1989 Porsche 911 Carrera 4 Coupe AWD F6-3600cc 3.6L SOHC

Cylinder Heads - Refacing Information

9404

Refacing Cylinder Heads with Use of Tool 9526

Figure 1

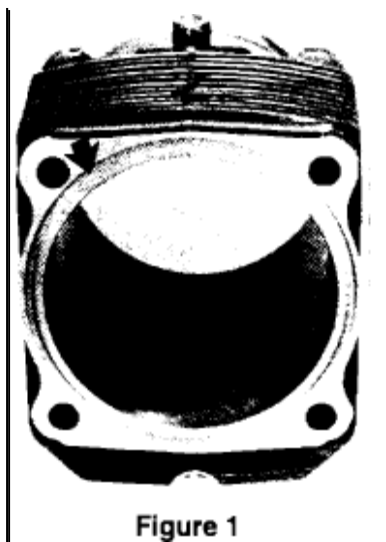
IMPORTANT: Replacement [piston](#) and cylinder sets have a groove to accommodate a seal between the cylinder head and cylinder mating surface (Figure 1). Effective immediately, only the steel sealing ring, Part Number 964 104 115 20 is to be used during repairs. This information also applies to engines produced after the above mentioned engine numbers.

When installing the cylinder head to the cylinder, the steel sealing ring must be fully installed in the groove of the cylinder. Sparingly use light grease to hold the ring in the cylinder during installation.

Figure 4

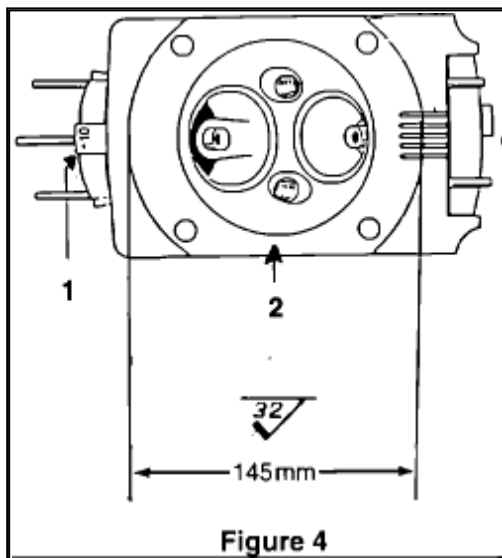
5. Machine $0.10 \pm .02$ mm from inner surface (arrow 2 in Figure 4). The diameter of the machined surface must be 145 mm (Figure 4). A surface quality standard of 32 micro-inches must be maintained. Machining should be done with a cutting tool at right angle to the work. The cylinder head surface may only be machined a maximum of 0.20 mm.

When machining is complete, the mating surface of the cylinder head to cylinder must be 145 mm in diameter.

6. Mark cylinder head with -10 or -20 appropriately on intake flange (arrow in Figure 4).
